Appendix I – Response to Comments on the 90% Design Documents (Basis of Design Report, O&M Manual, Construction/Remedial Action Work Plan)

Groundwater Remedy Basis of Design Report/Final (100%) Design

PG&E Topock Compressor Station, Needles, California

Figure 2. Major proposed remedial components and water routing.⁴

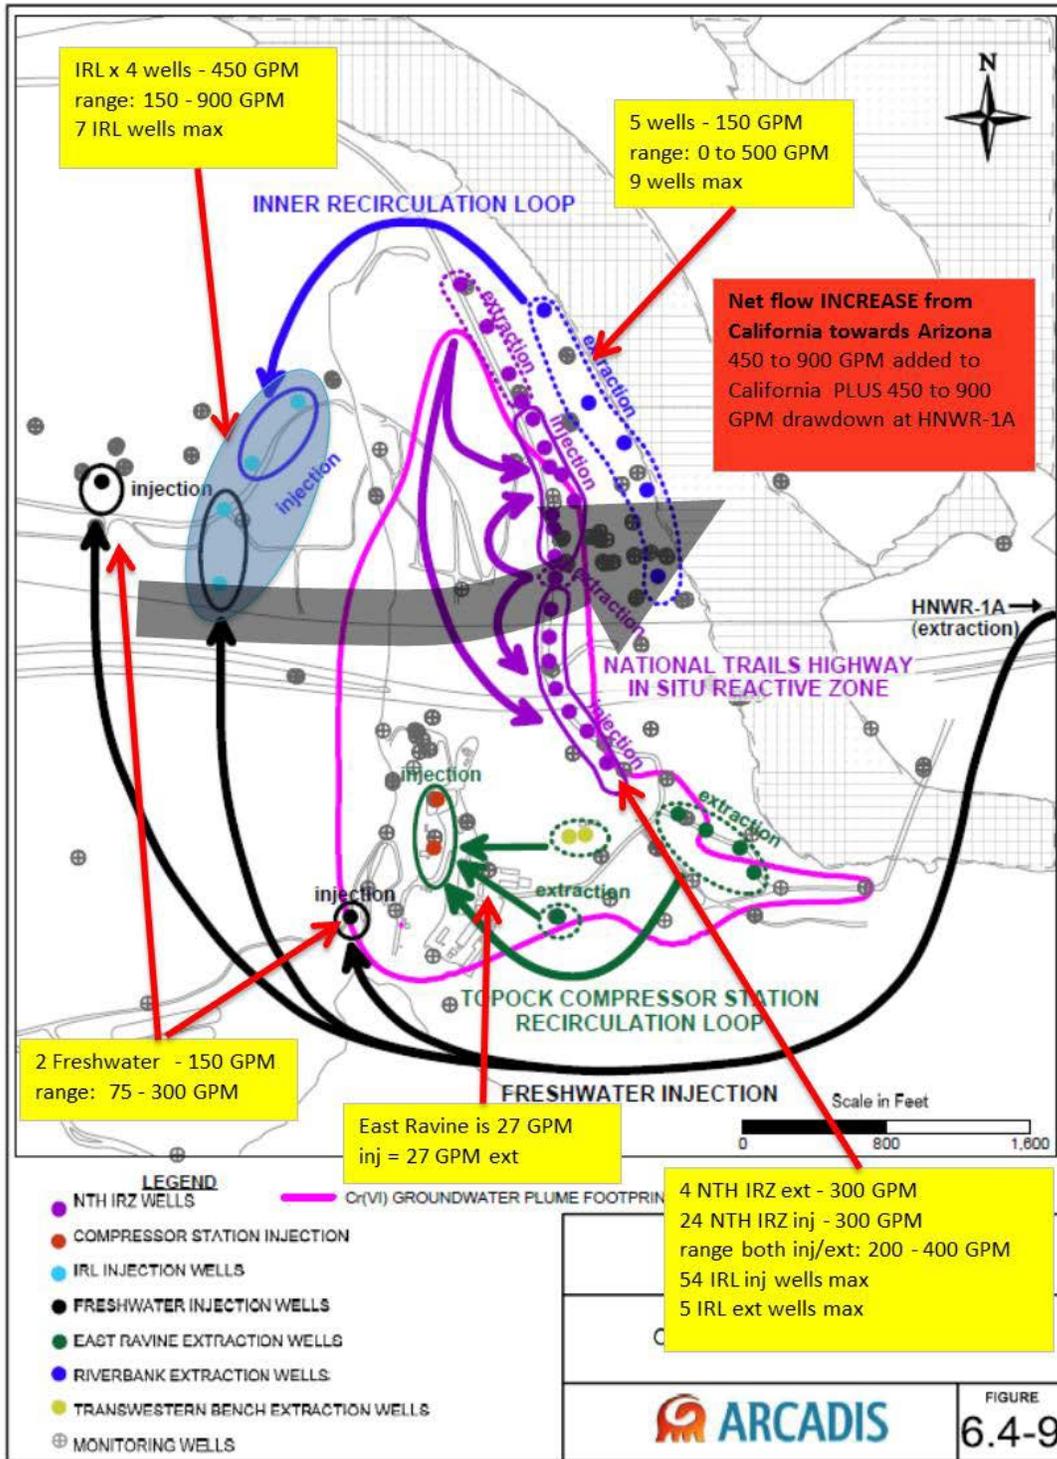
4	ADEQ					<p>The installation of groundwater wells and the continued monitoring of hydraulic and hydrologic conditions and groundwater quality with respect to hexavalent chromium (Cr VI) and, more recently, remediation byproducts on the Arizona side of the Colorado River have been, and continue to be, important to this agency and others. The technical, practical, and sensitive importance has been documented previously by several entities.</p> <p>For the record, ADEQ supports the technical and practical components that have led PG&E to the proposed locations of MW-X and MW-Y. With the recent confirmation that the increasing concentration of Cr VI in MW-55-120 are statistically significant, ADEQ echoes the DTSC’s sentiments expressed during the TWG meeting that more than two additional monitor wells on the Arizona side of the Colorado River are ideal. However, ADEQ will heed to the compromise of two additional monitor wells on the Havasu National Wildlife Refuge (HNWR) peninsula, as long as the VRP decision criteria outlined in 2007 continue to be met:</p> <ul style="list-style-type: none"> Exceedances of the total chromium Arizona Aquifer Water Quality Standard (AWQS) of 100 micrograms per liter (µg/L) do not occur; and Cr VI concentrations are not detected above the regional natural background concentration of 32 µg/L. <p>Once the groundwater remediation system is operational, the WRP will have additional decision criteria that will need to be met such as:</p> <ul style="list-style-type: none"> Remediation system byproducts are not to be detected above their respective AWQSs; and Changes in groundwater quality parameters are not to be determined statistically significant. Specific groundwater quality parameters and preferred statistical analysis methods and bounds will be outlined at a later date. <p>ADEQ acknowledges concerns expressed by the various Tribal stakeholders regarding the cultural significance of the HNWR peninsula as well as the region as a whole. ADEQ recognizes that federal agencies have primary jurisdiction over the HNWR and a decision on whether to drill on the peninsula, and where, will be made through the federal consultation and approval process. ADEQ’s mission is to protect human health and the environment and requests to remain a participant in the consultation process to advocate the continued protection of our residents and environment.</p>	Comment noted.				<p>This RTC was discussed at the July 23, August 18, and August 26 TWG meetings.</p> <p>DTSC/DOI – Comment noted. The Agencies will provide final direction to PG&E with respect to MW-X and Y</p>
